DVC PLAZA AND HOOKSTON STATION AMENDMENTS TO THE PLEASANT HILL COMMONS REDEVELOPMENT PLAN

Final Environmental Impact Report
Reflecting Errata

SCH No. 2008032042

CHAPTER 3 Response to Comments

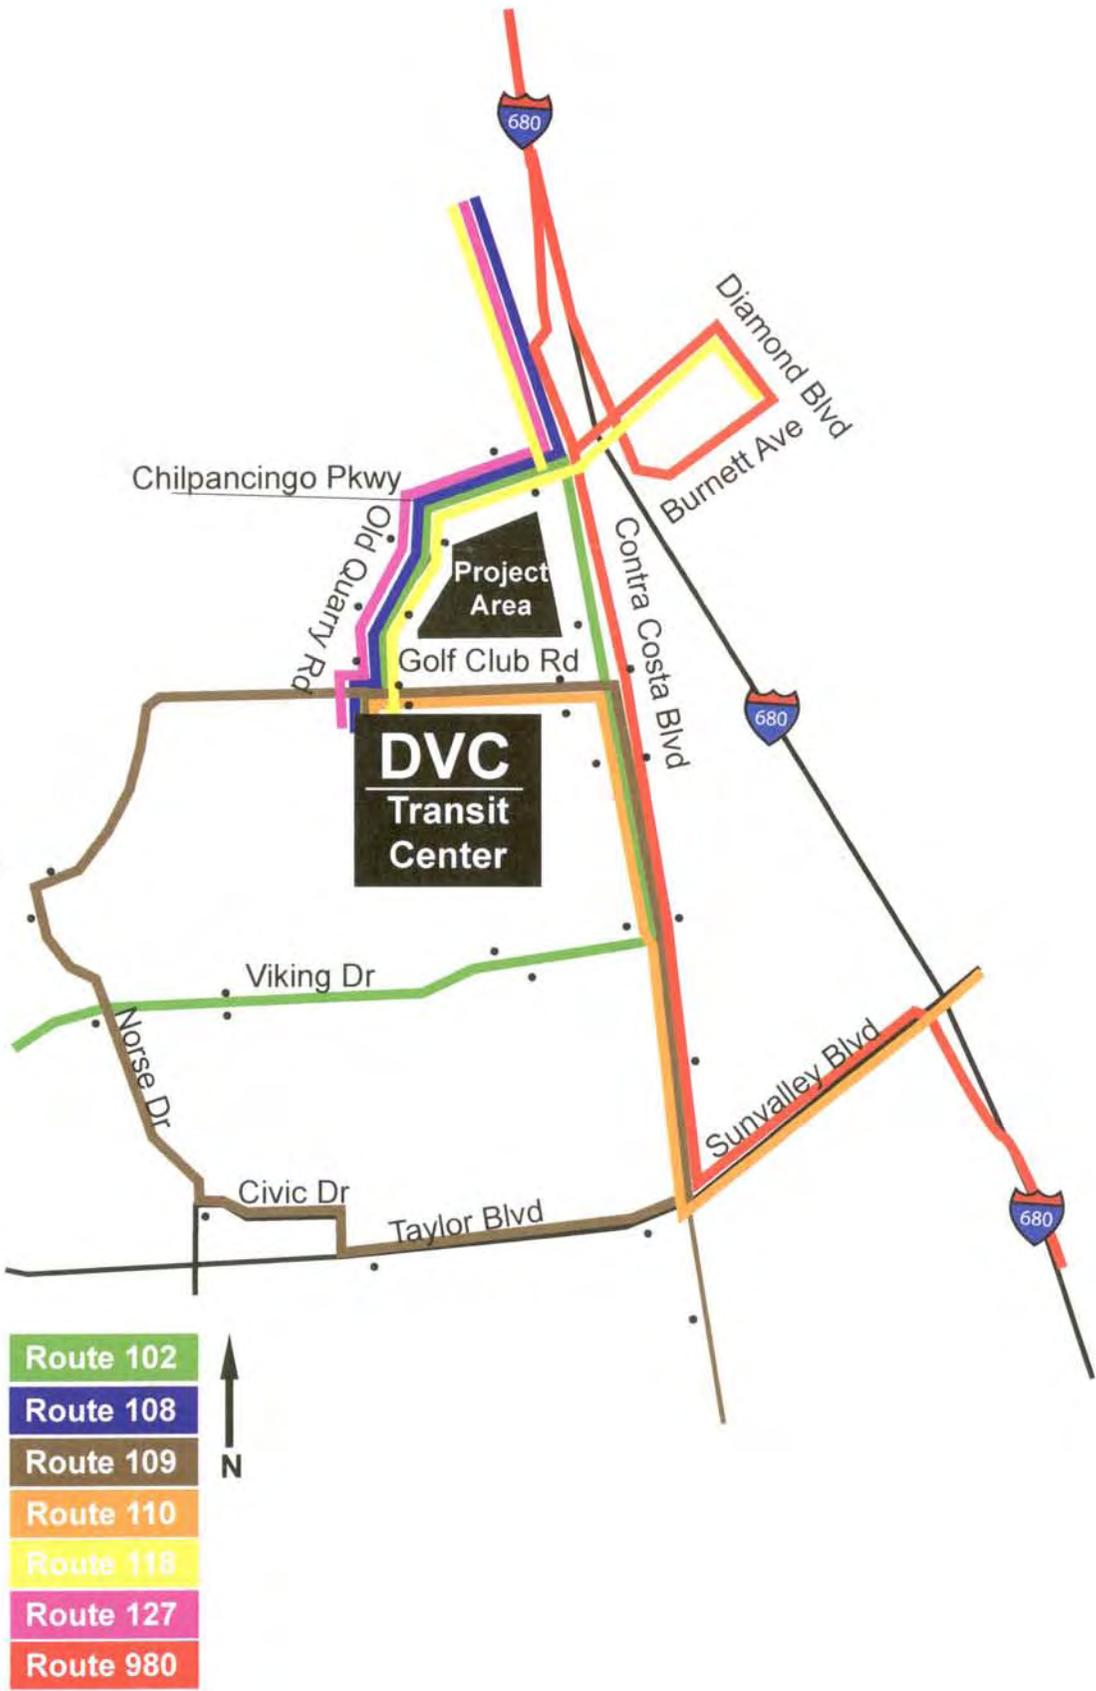
The transportation element of the plan needs to be edited to accurately reflect bus transit services to the project area. Routes 102, 108, 109, 127, 980, and 110 serve the DVC Plaza area on weekdays and provide connections to the North Concord, Concord, Pleasant Hill and Walnut Creek BART stations. A map showing how the various routes serve the project area is attached.

- 3-1 The comment requests that the transportation chapter of the EIR be revised to accurately reflect bus transit services that serve the project area. Specifically, the comment listed several additional bus routes that serve the DVC Plaza Area. Descriptions of the additional routes serving the DVC Plaza Area identified by the County were added to Chapter 4 of the DEIR (See Chapter 2, Text Changes).

Diablo Valley College Transit Center
CONCEPT MASTER PLAN / Alternative I (revised)

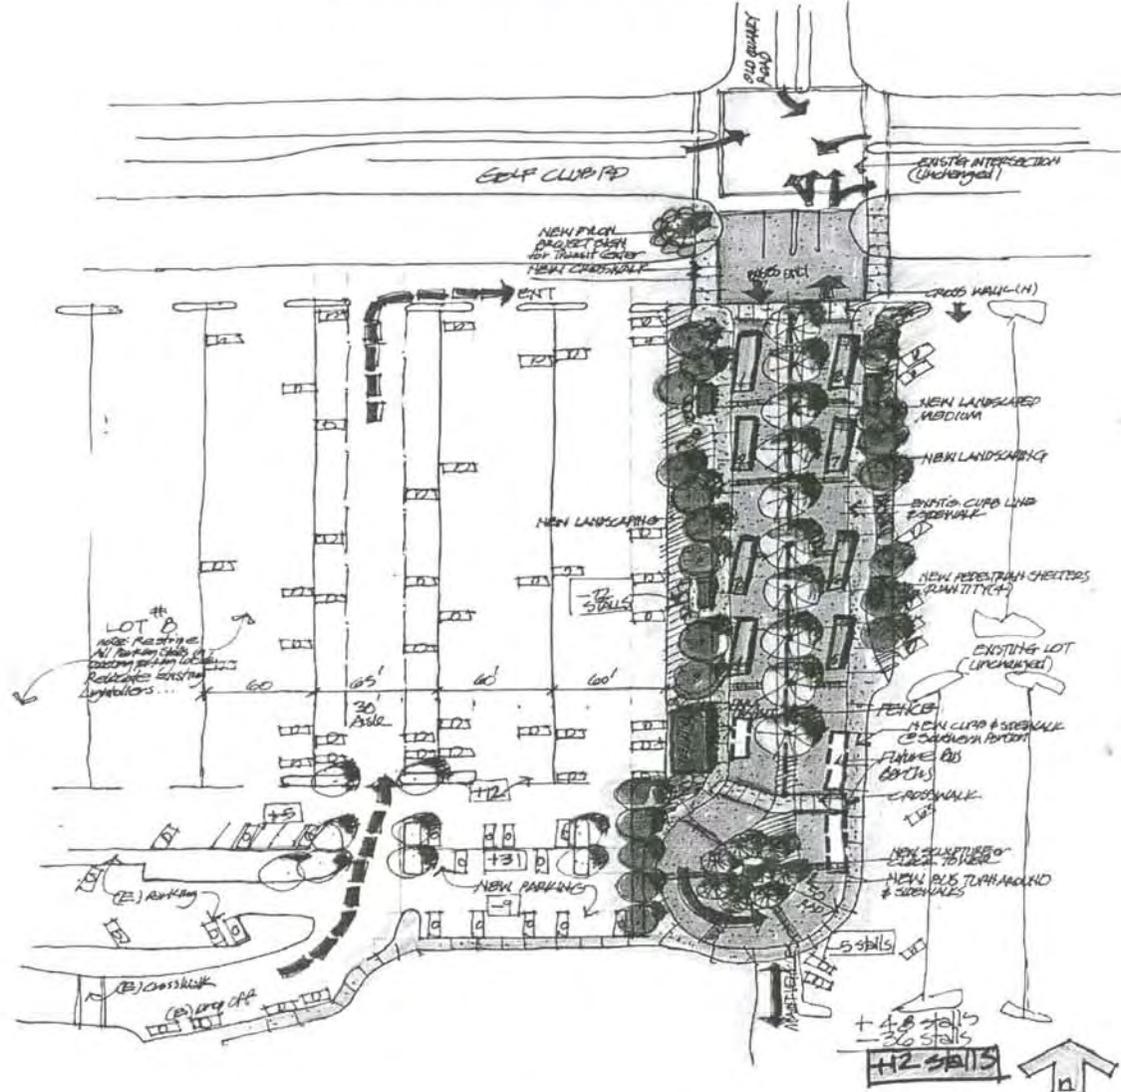
In addition the transportation element of the plan should reference the development of the DVC Transit Center located on across Golf Club Road from the project area. A design schematic has been attached for reference.

- 3-2 The comment requests that the transportation element of the redevelopment plan reference the development of the DVC Transit Center. The DEIR did provide descriptions of the bus routes that serve the project areas and descriptions of the additional routes serving the DVC Plaza Area were added to the DEIR (See Chapter 2, Text Changes). These descriptions included references to the new DVC Transit Center, which would include 10 bus bays, passenger waiting area, lighted loading islands, separation of buses and personal vehicles at access and egress, and a transit ticket office.
